Match ellis project name:
CLE/WAR SR 48 6.65 Sidewalk

CLE/WAR SR48 6.65 & BUTTERWORTH SIDEWALK

STAGE 1 SUBMITTAL - AUGUST 29, 2025

TITLE SHEET

STATE ROUTE 48 & OVERLOOK DRIVE
SCHEMATIC PLAN

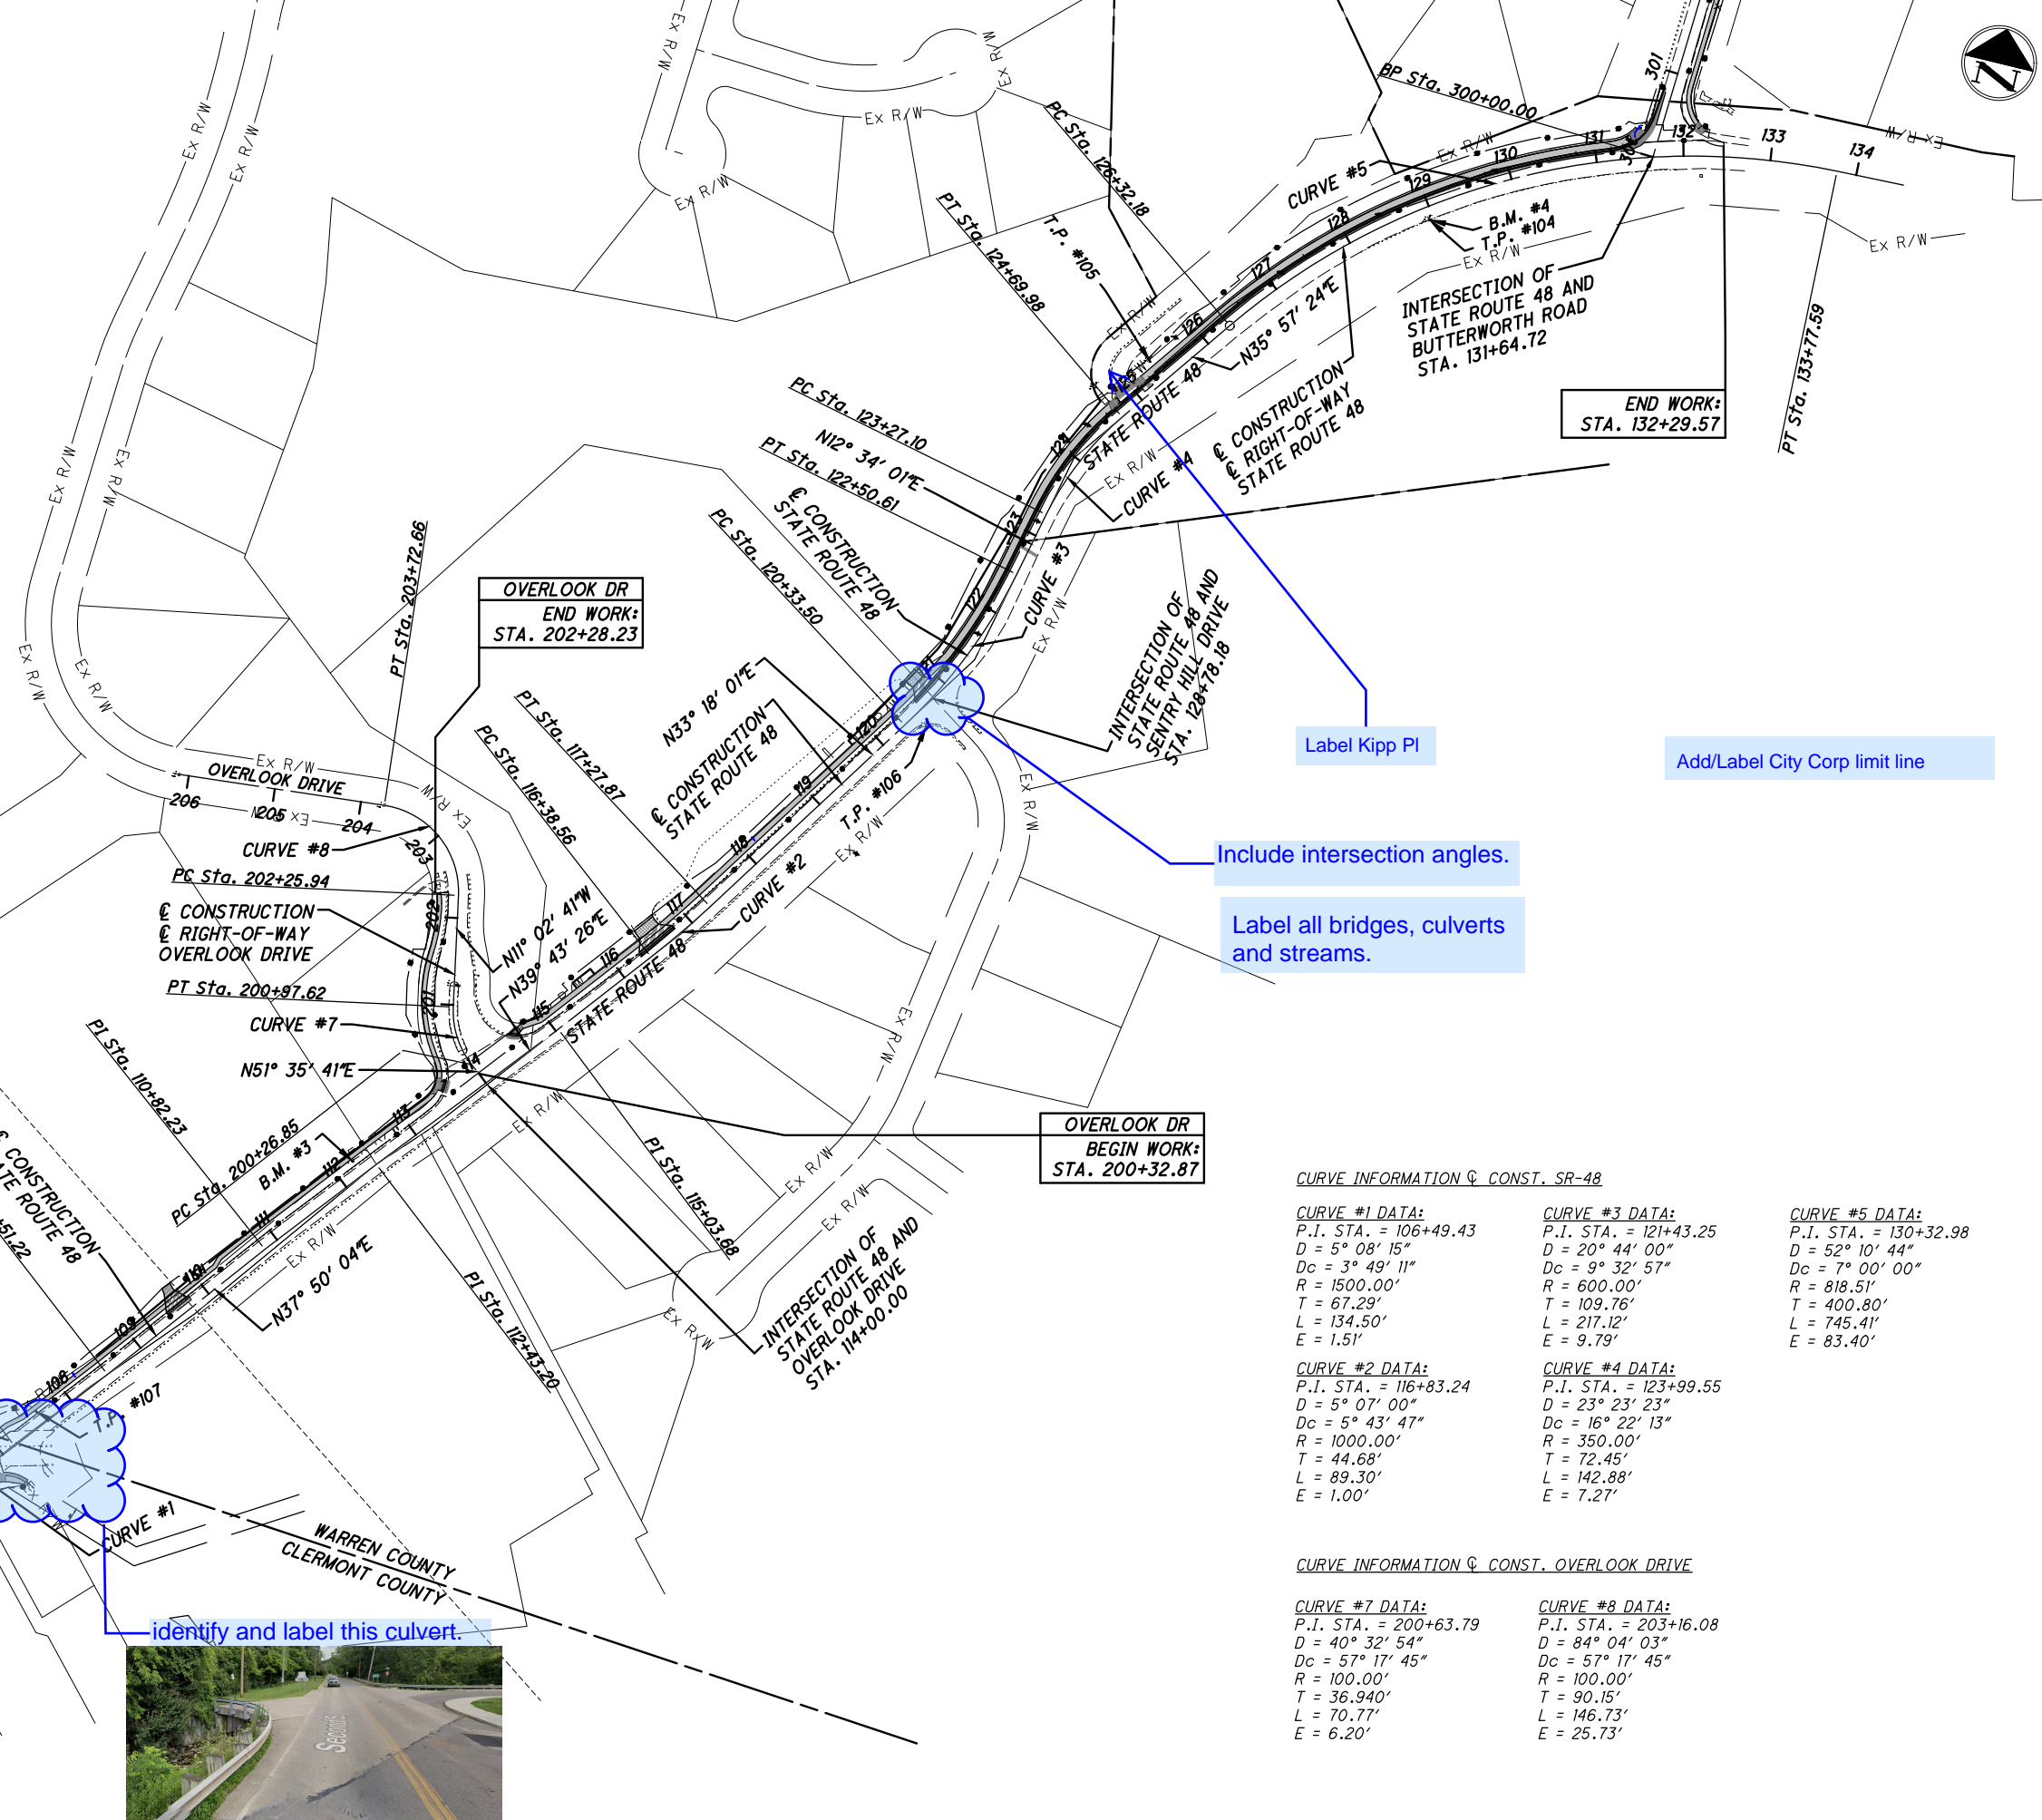
identify and label this culvert.

Label Kipp PI

Add/Label City Corp limit line

**BUTTERWORTH ROAD
SCHEMATIC PLAN**

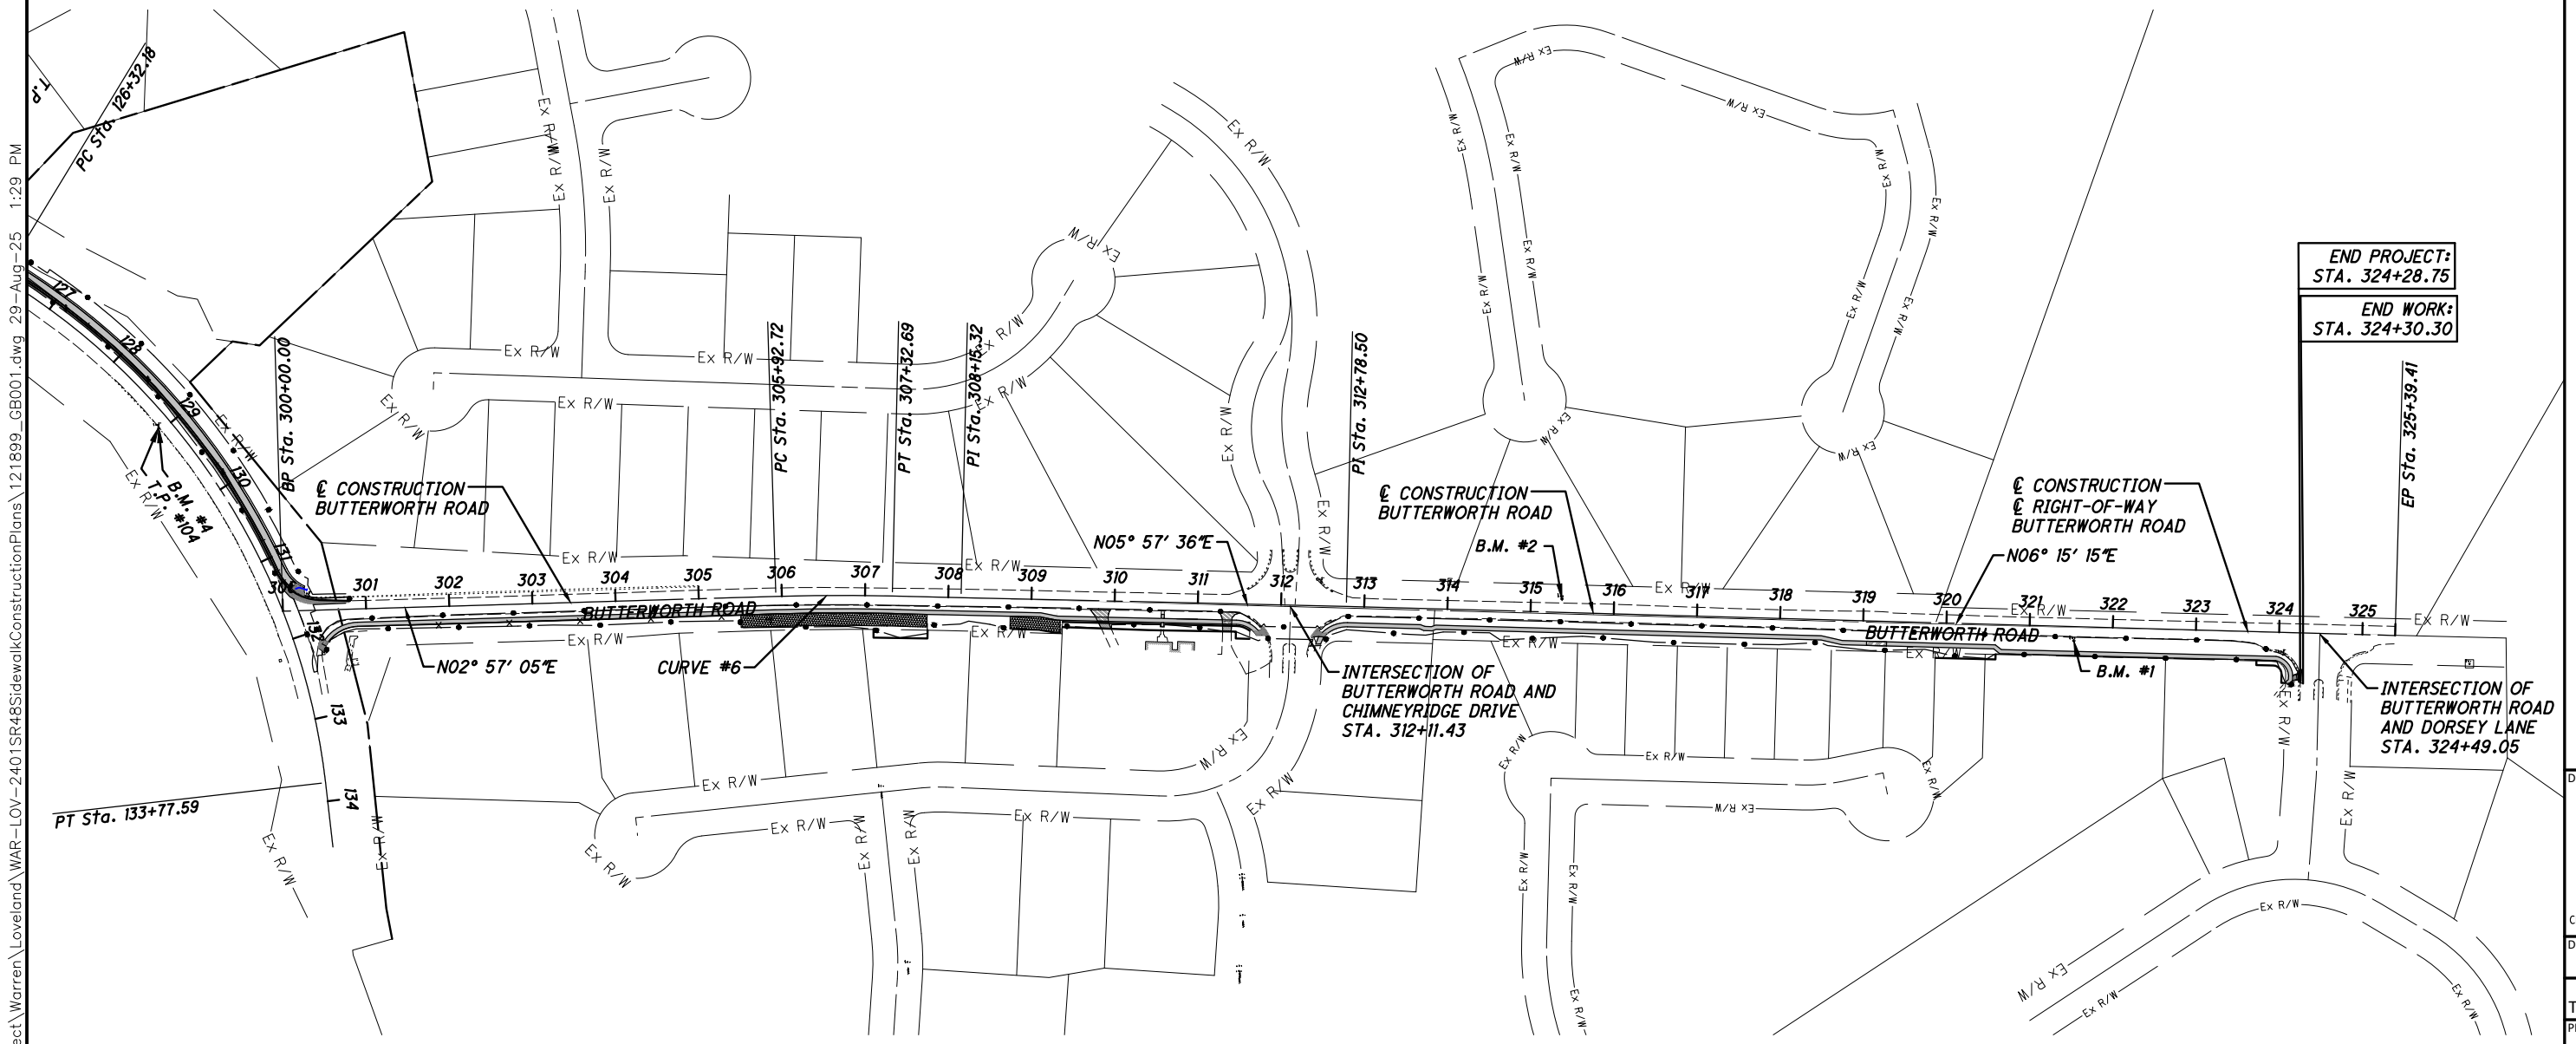
Add/Label City Corp limit line

PLAN AND PROFILE - STATE ROUTE 48
STA. 101+00 TO STA. 106+00

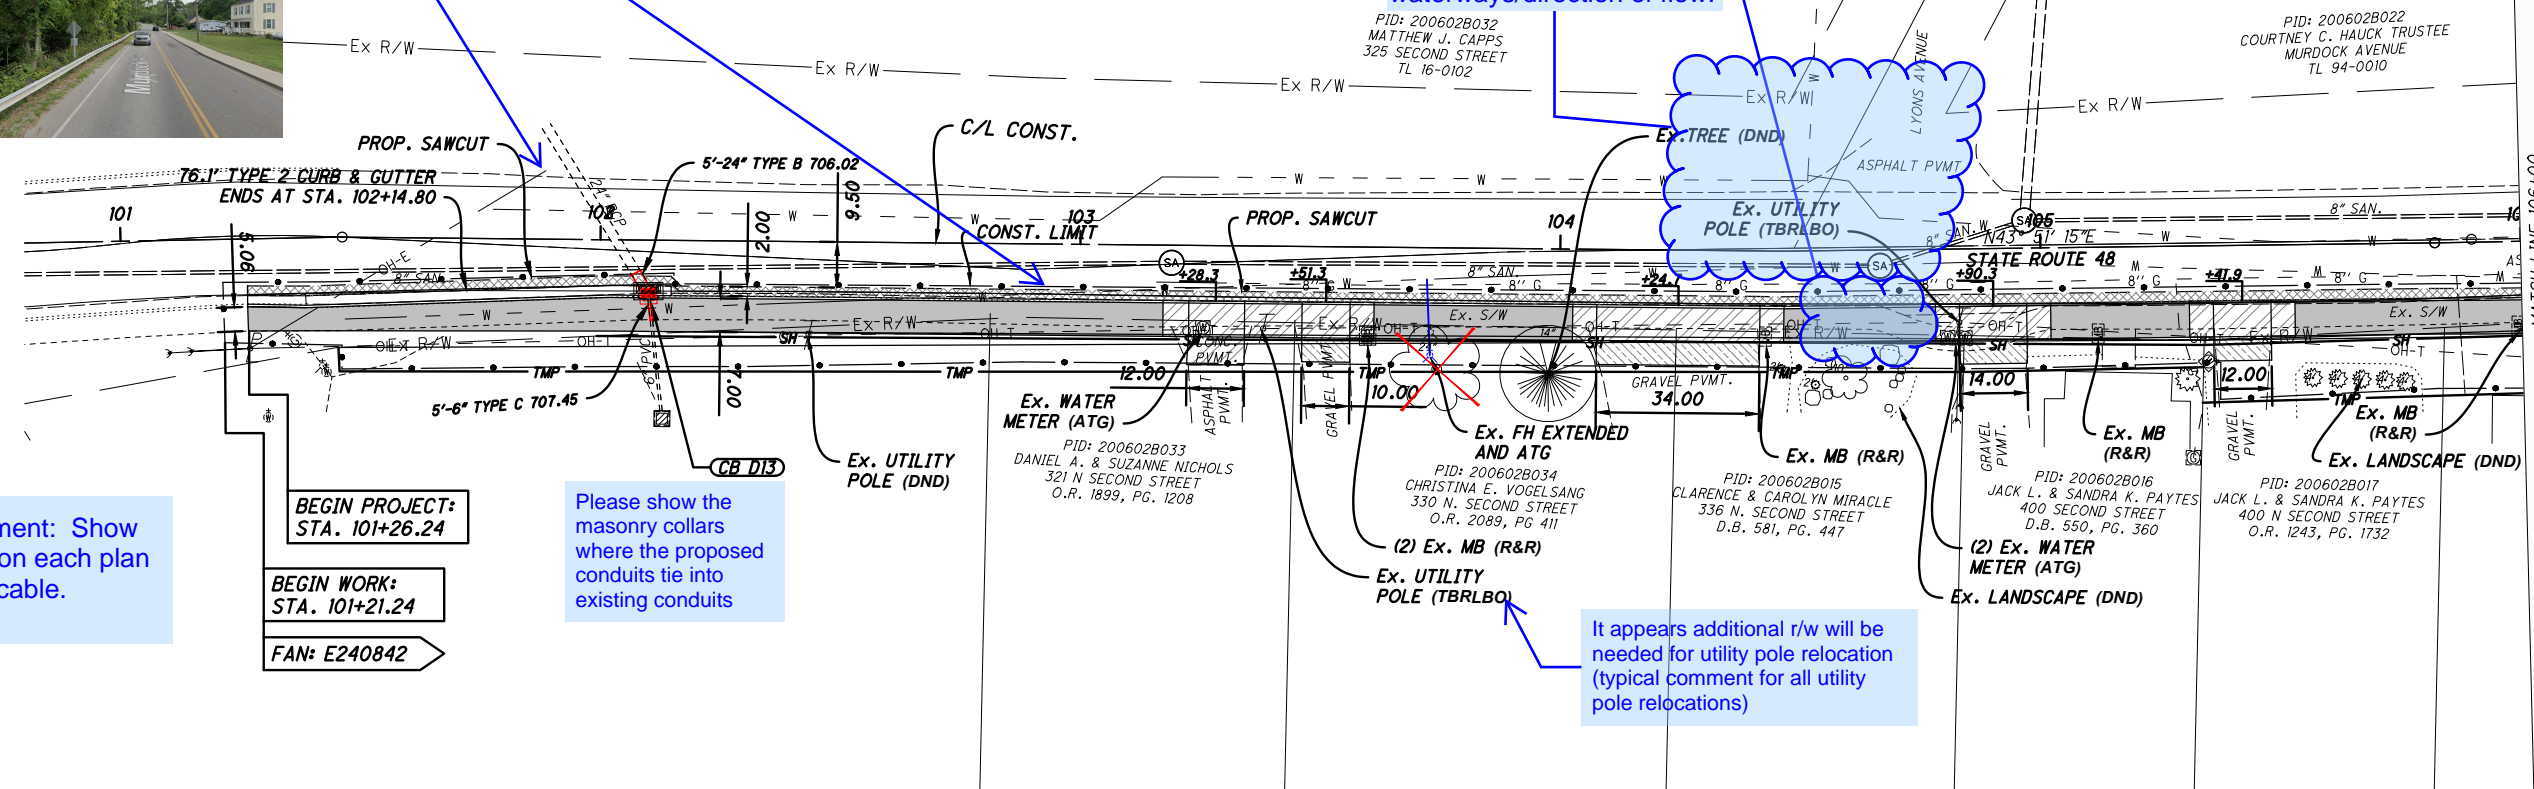
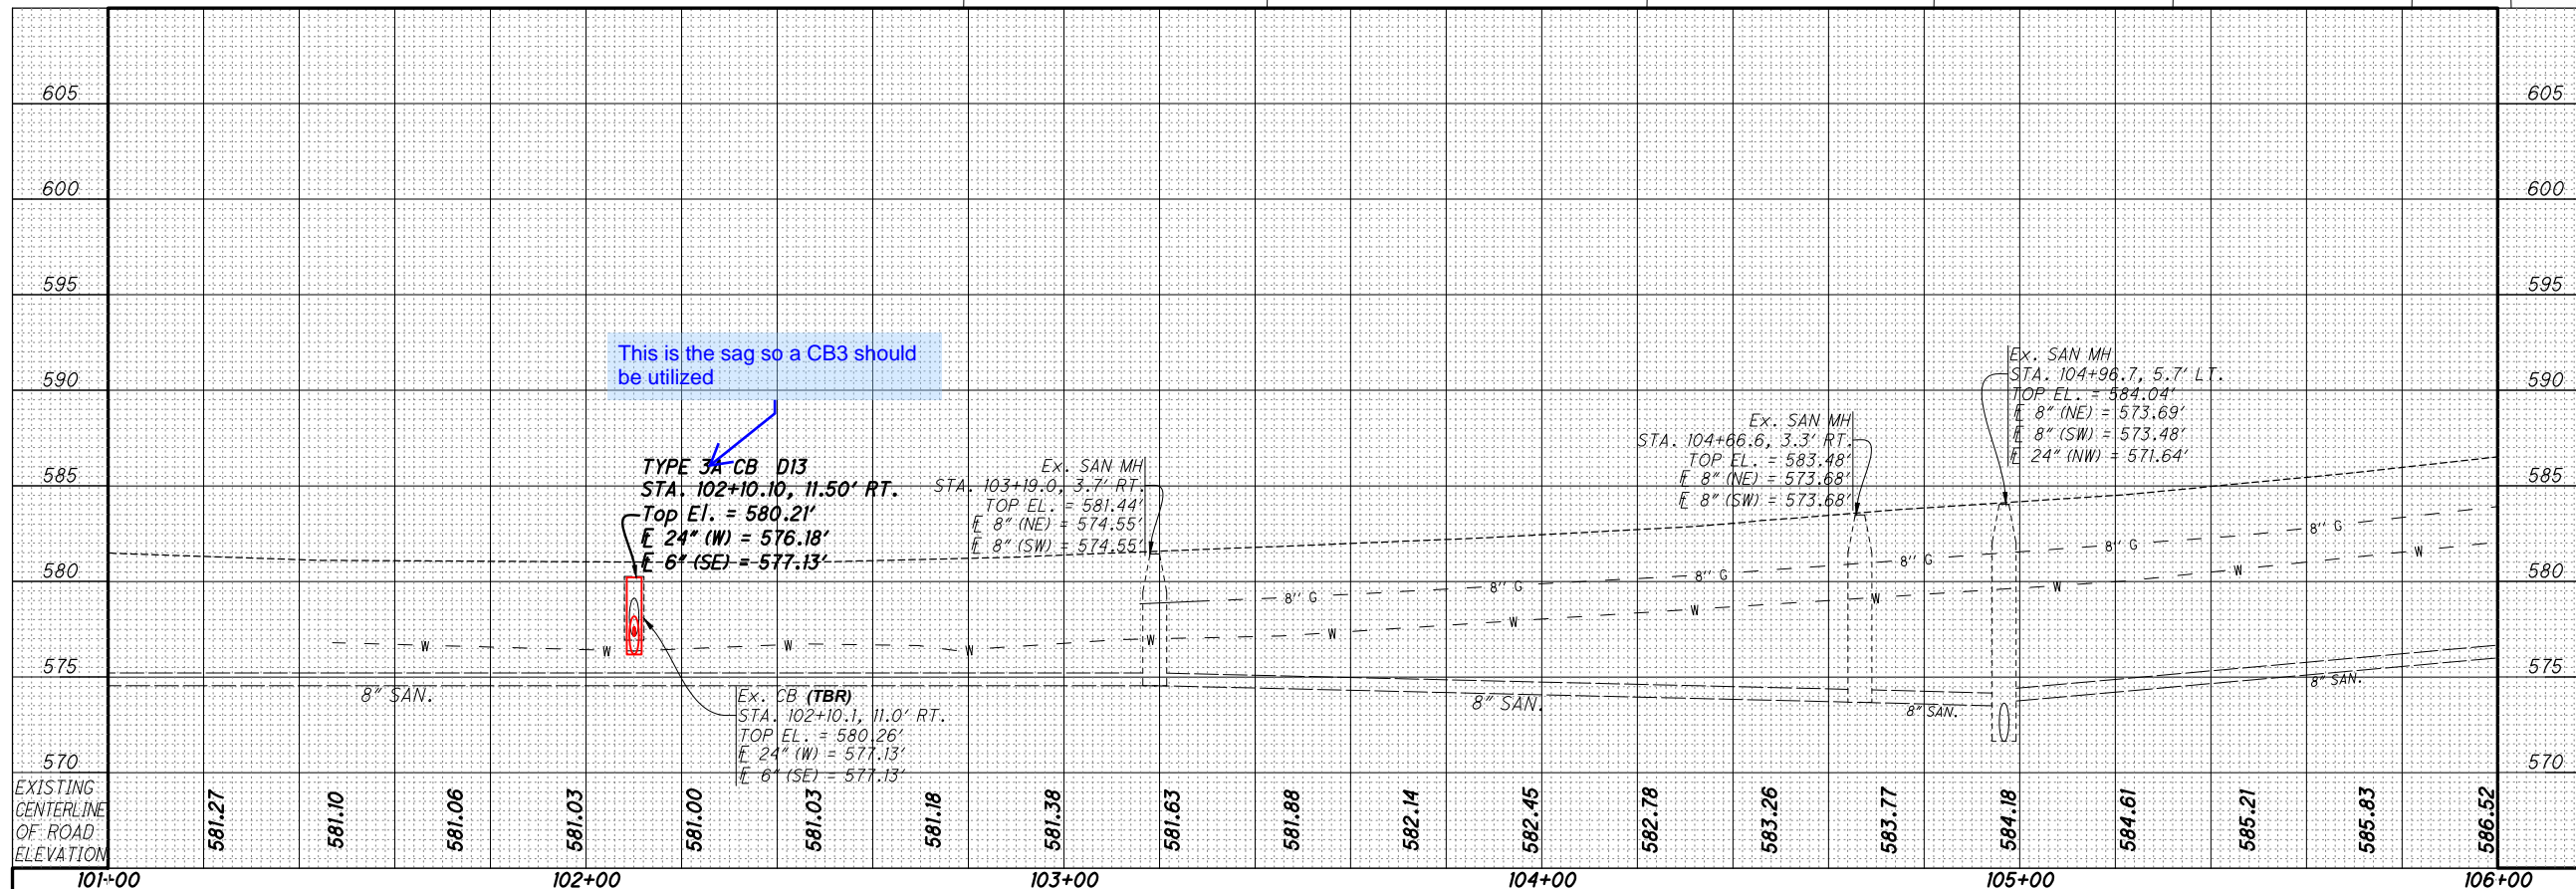
There is a stream that runs along SR48 that needs to be identified and labeled properly on the plans. Show existing GR.

Check the plans to verify it calls for existing sidewalk to be removed.

Include names and bearings of intersecting side streets. Show existing structures and waterways/direction of flow.

General Comment: Show all curve data on each plan sheet as applicable.

Please show the masonry collars where the proposed conduits tie into existing conduits

It appears additional r/w will be needed for utility pole relocation (typical comment for all utility pole relocations)

This is the sag so a CB3 should be utilized
